STATE OF FLORIDA
DEPARTMENT OF ENVIRONMENTAL REGULATION

IN RE:)
)
Florida Power & Light Company)
St. Lucie Power Plant Unit No. 2:)
Modification of Terms and Condi-)
tions of Certification No.)
PA-74-02, St. Lucie County,)
Florida,)
)
Petitioner.)
)

PETITION FOR MODIFICATION
OF CONDITIONS OF CERTIFICATION

UNIT 2 OCEAN DISCHARGE STRUCTURE
 (Original Alternating Diffuser
 Design)

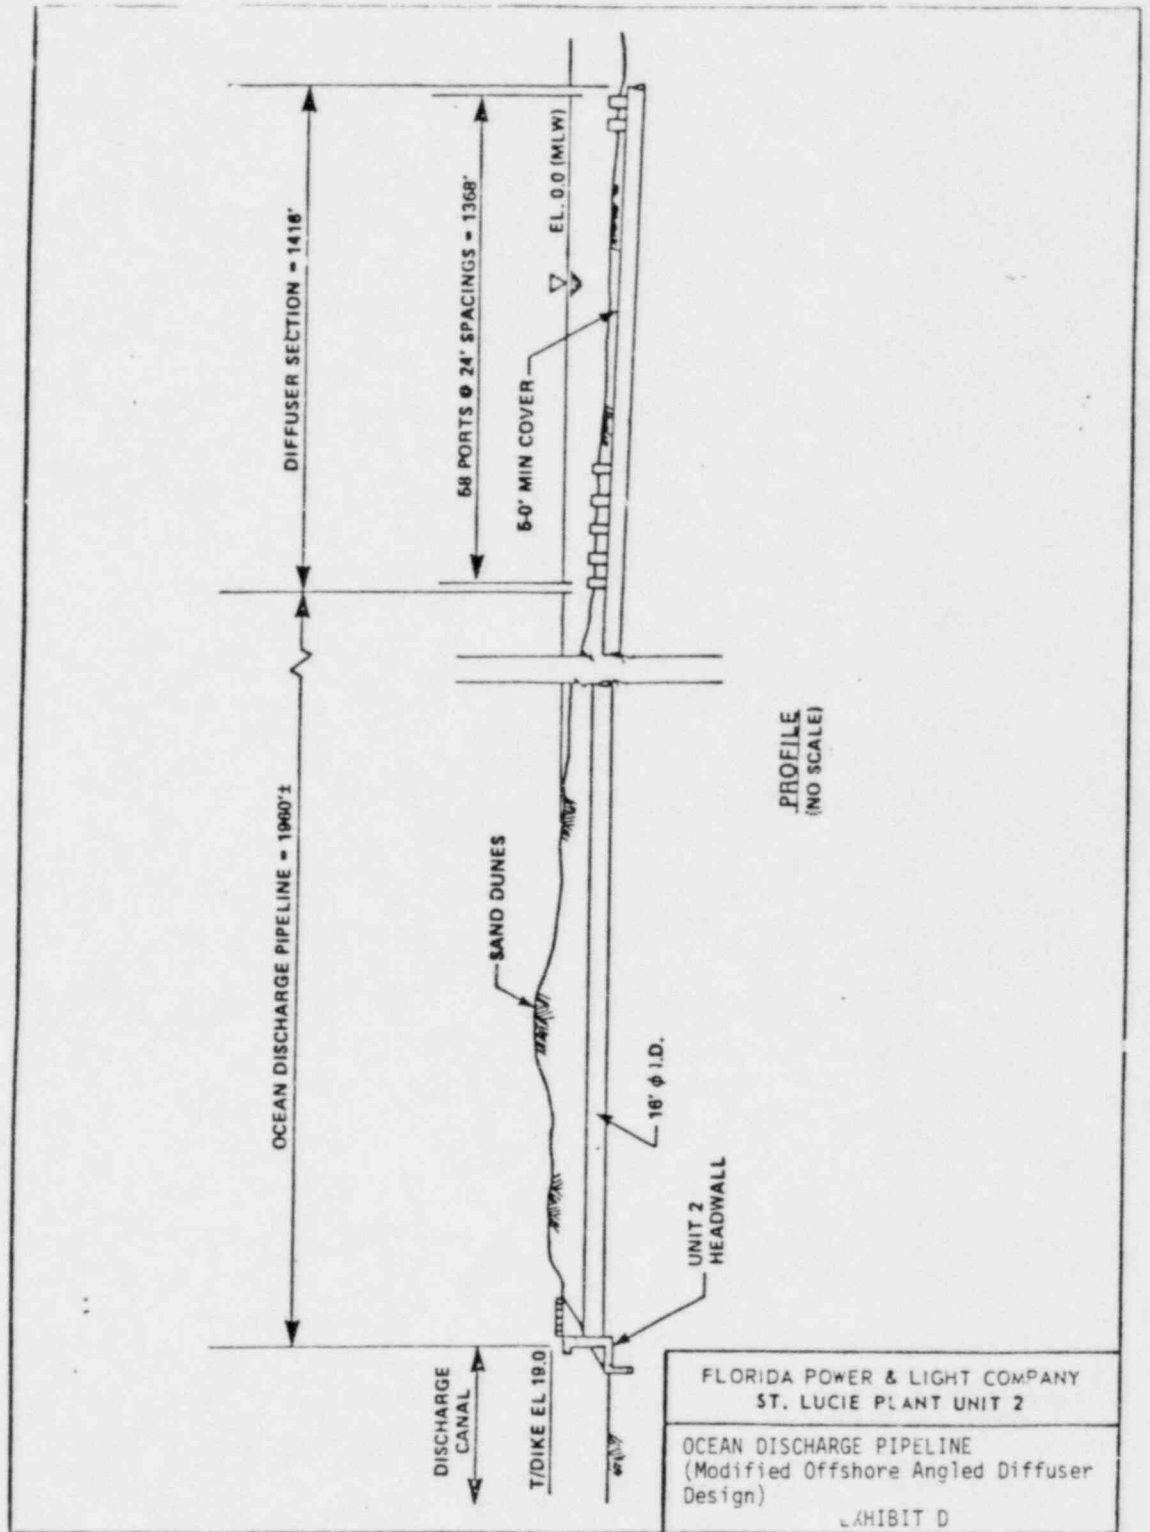
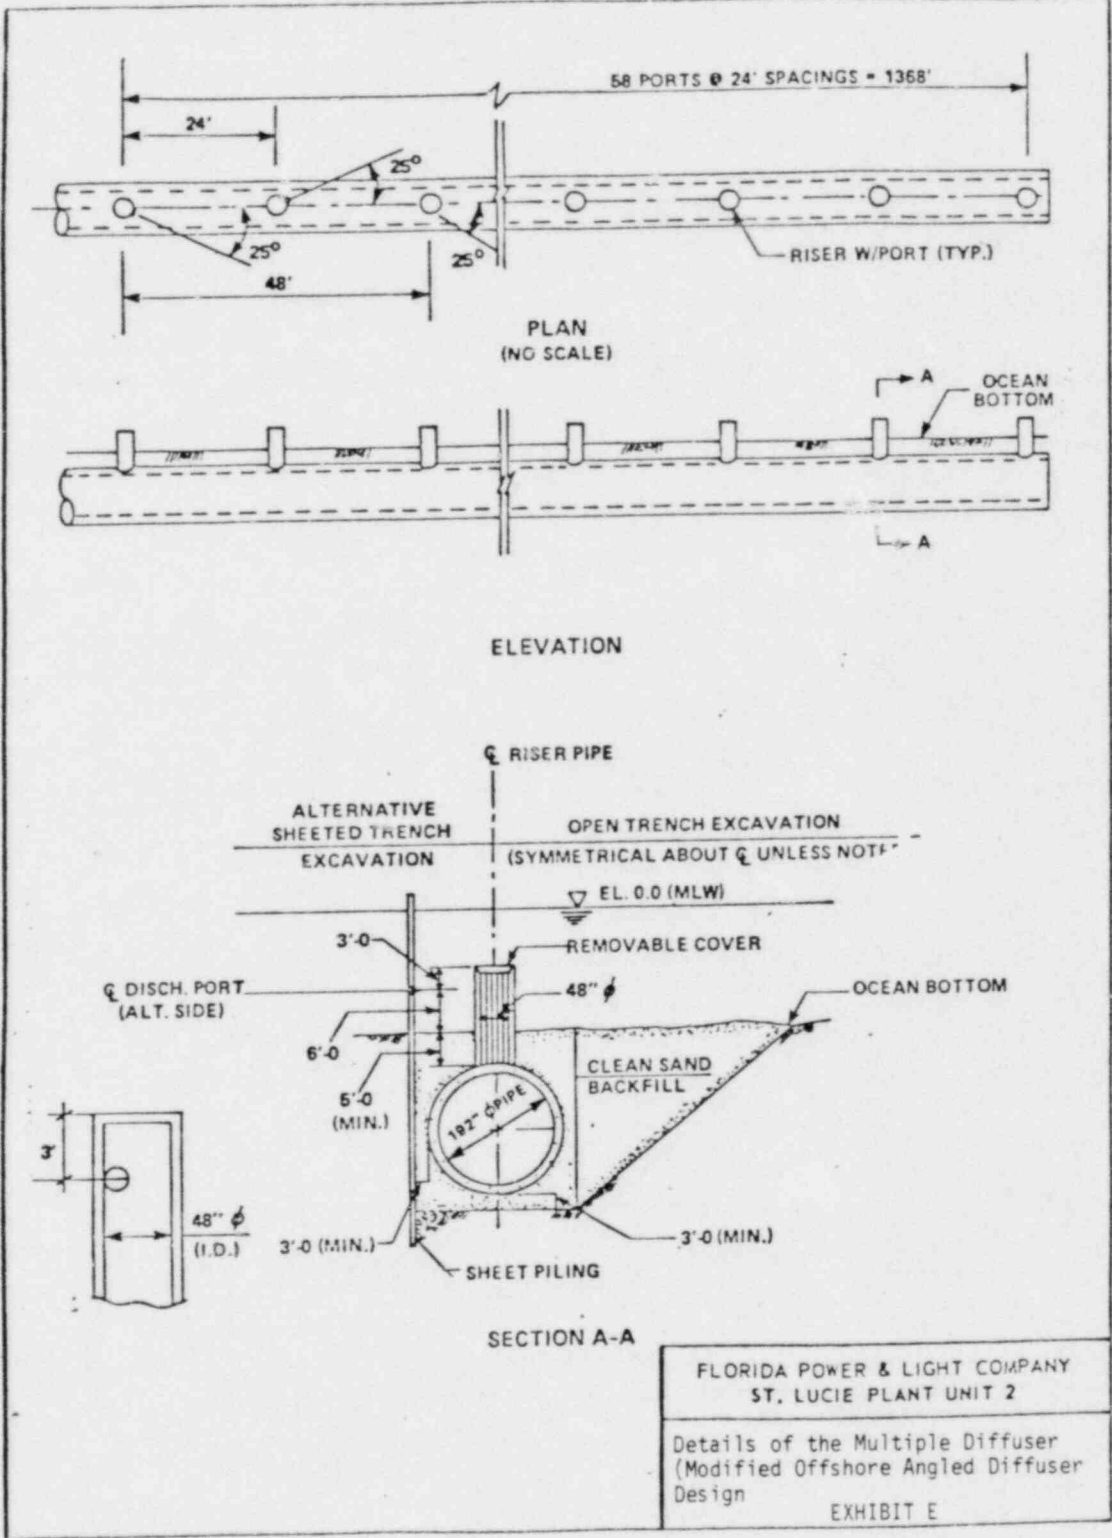
15. The modified offshore angled diffuser, approved by the Board by order dated April 7, 1980, consists of a 16-foot diameter (inside diameter) buried concrete conduit that extends into the Atlantic Ocean approximately 3,050 to 3,070 feet from the shoreline. The last 1,380 to 1,400 feet of the pipe is mounted with 58 four-foot diameter riser pipes spaced 24 feet between centers that extend above the ocean bottom and have 16-inch ports oriented to discharge at a 25° angle from the centerline of the diffuser, directed offshore. (See Exhibits D and E.)
